SUBJECT: Forwards comments on preliminary accident sequence  
precursor analysis (LER 251-92-007) delineated in  
NUREG/CR-4674, "Precursors to Potential Severe Core Damage  
Accidents:1992,Status Rept," per NRC 930602 request.

Re: Turkey Point Units 3 and 4  
Docket Nos. 50-250 and 50-251  
Review of Accident Sequence Precursor B.6 in the  
Draft 1992 NUREG/CR-4674 Report

FLORIDA POWER & LIGHT COMPANY  
REVIEW OF (PRELIMINARY) SECTION B.6 OF  
NUREG/CR-4674  
"PRECURSORS TO POTENTIAL SEVERE  
CORE DAMAGE ACCIDENTS"

Figure 4

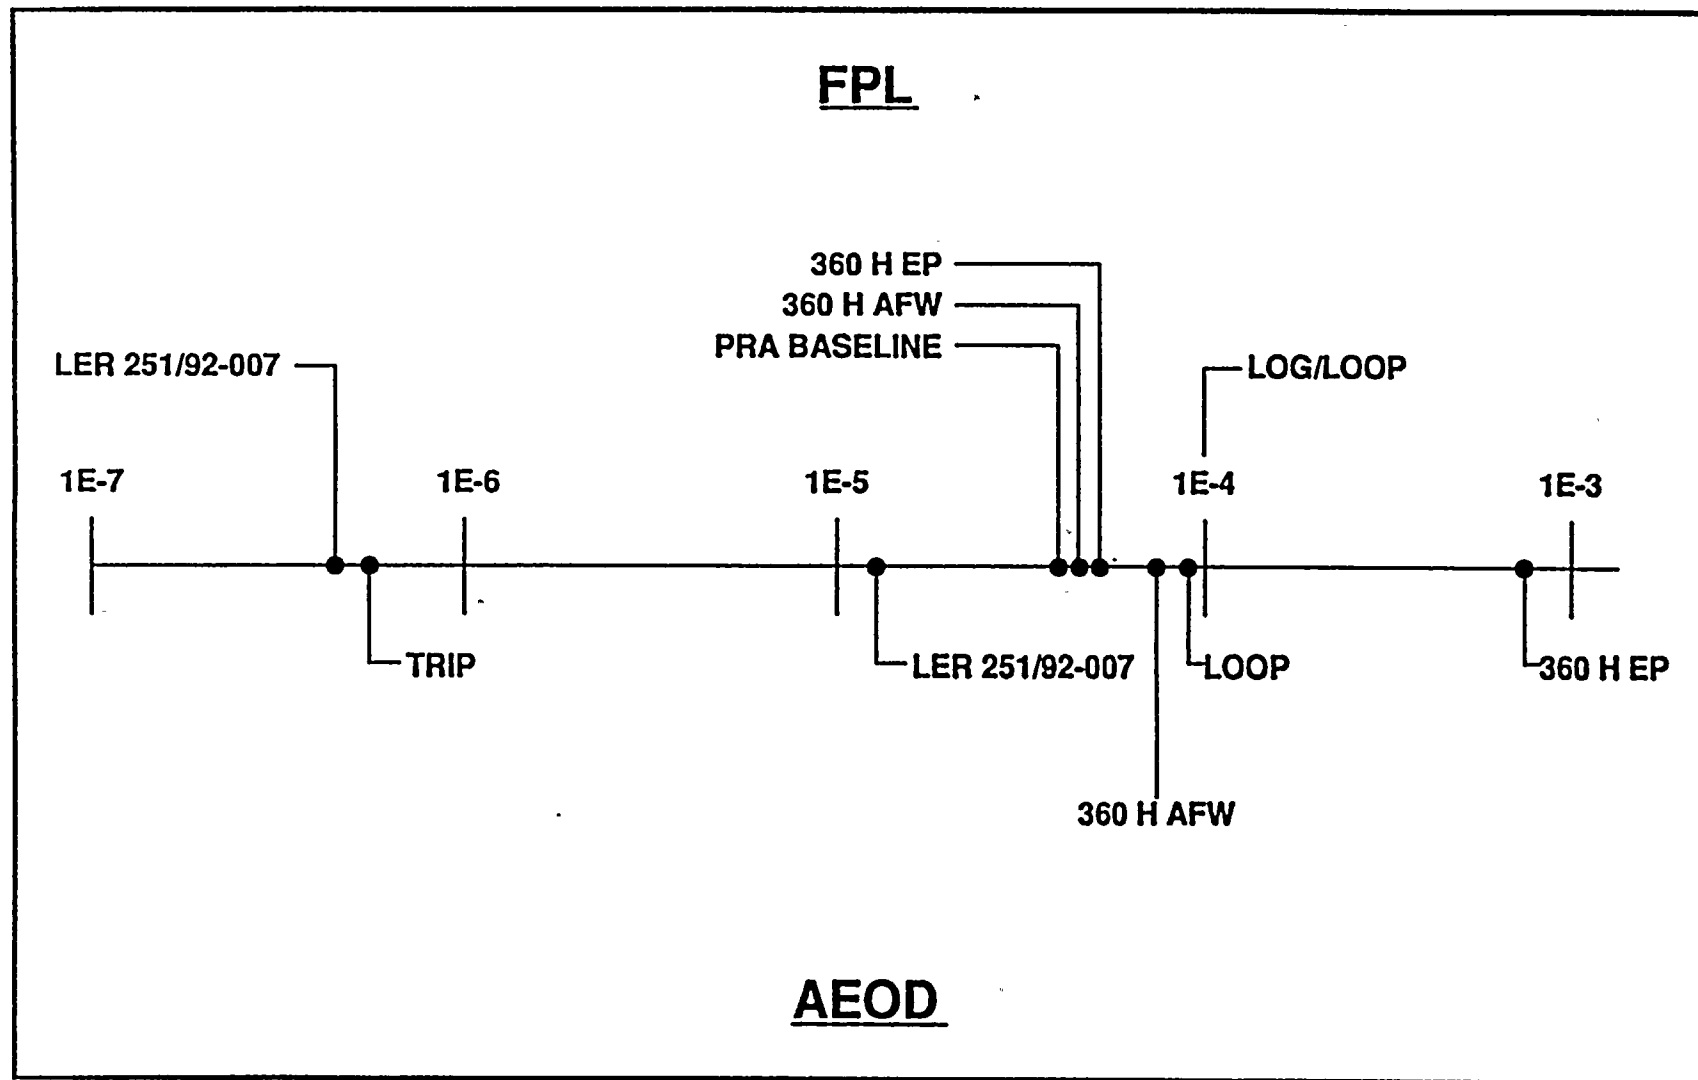
As shown in Table 1, the Core Damage Frequency (CDF) calculated for the LER 251-92-007 scenario using the Turkey Point PRA is substantially smaller than that calculated in the three sequences used by AEOD. But, as the Turkey Point model uses a single sequence for this calculation, further analysis was performed. To more closely compare the Turkey Point PRA model to the results of the AEOD study, new top logic was created, generating sequences identical to those in the AEOD event tree (Figure B.6 of the draft NUREG), and the model was rerun. As shown in Table 1, the dominant sequence is

identical to that calculated in the AEOD study, and the sequences show a significantly smaller CDF.
